Re: MVCA Technical Review Memorandum (dated July 8, 2022, Revised August 24, 2022)
Slope Stability Engineering Review

Hilan Village Residential Subdivision Application,
38 Carss Street, Almonte Ontario
File Number 09-T-22003

Figure 115 b - Stable Slope Allowance
(toe of valley slope $\leq 15\text{m}$ from watercourse)

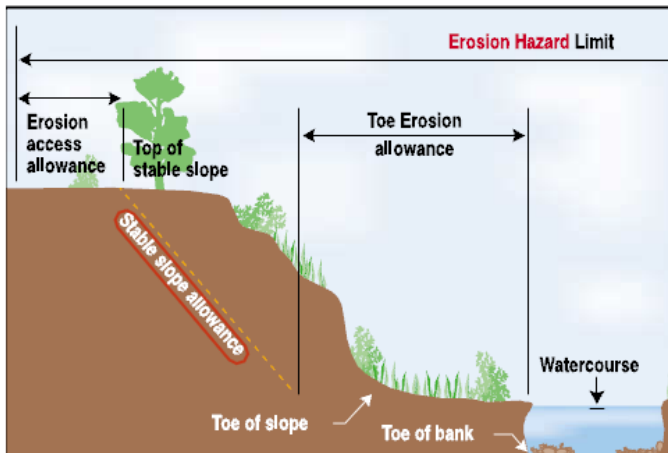
- It appears that Table 3 was applied correctly with respect to the slope and the chosen toe erosion allowance of 6 m. However, we note that this 6 m allowance was excluded from the overall hazard calculation, without providing any supporting inspection data/study. More details and scientific justification are required in omitting the toe erosion allowance.

Figure 115b – Stable Slope Allowance was copied from the MNRF guidelines. This figure clearly illustrates that the toe erosion allowance is measured from the toe of the slope where the toe of the slope is less than 15 metres from the toe of the bank. As discussed on page 10 and 11 of the report, the application of 6 metres of toe erosion allowance at the toe of the slope will not change the overall stability of the slope or cause the stable slope allowance to immerge past the top of the slope.

Additional analysis was completed modelling the slopes assuming 6 metres of erosion occurred at the toe of the slope. Where there was less than 6 metres of overburden (measured horizontally) between the existing toe of the slope and the bedrock, the overburden was removed to bedrock. This additional analysis has been added to the report and provides engineering support for the statements made on page 10 and 11 of the report with respect to the toe erosion allowance.

Figure 123 - Erosion Access Allowance:

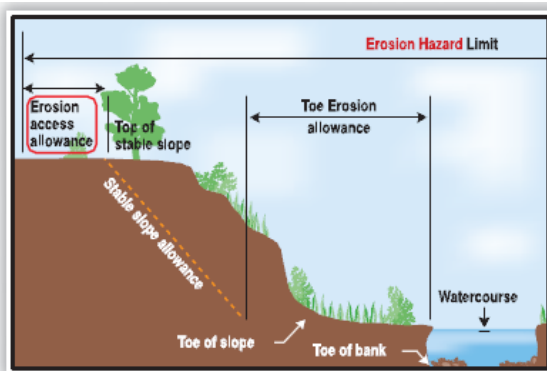
- The report uses access rationale to justify removing the 6 m erosion access allowance. For example, pg.11 of the report indicates “The length and height of the slope will prevent construction access to the majority of the slope for maintenance.” However, the MNR guideline states “Where municipalities and planning boards determine that the suggested 6 metre erosion

access allowance is excessive or not sufficient enough to provide the required public safety and site access, mechanisms should be incorporated into the planning process providing the flexibility to undertake a study using accepted scientific, geotechnical and engineering principles to determine the erosion access allowance.”

*In Figure 123, the erosion access allowance is being added to the stable slope allowance designated by a line marking the top of the stable slope. **This line marks the top of stable slope not the top of slope.** The erosion access allowance is not being added beginning at the top of the slope. In Figure 124, the excavator is operating within the erosion access allowance at some point below the top of slope as the slope clearly extends upward beyond the excavator.*

The wording and illustrations in the Technical Guide state that the erosion access allowance be added to the stable slope allowance after the stable slope allowance is added to the toe erosion allowance. The Figures 95b and 115b clearly illustrate that toe erosion allowance begins at the toe of the bank or at the watercourse. Figures 115a and 115b clearly illustrate that the stable slope allowance is applied either beginning at the toe of the slope or following the toe erosion allowance.
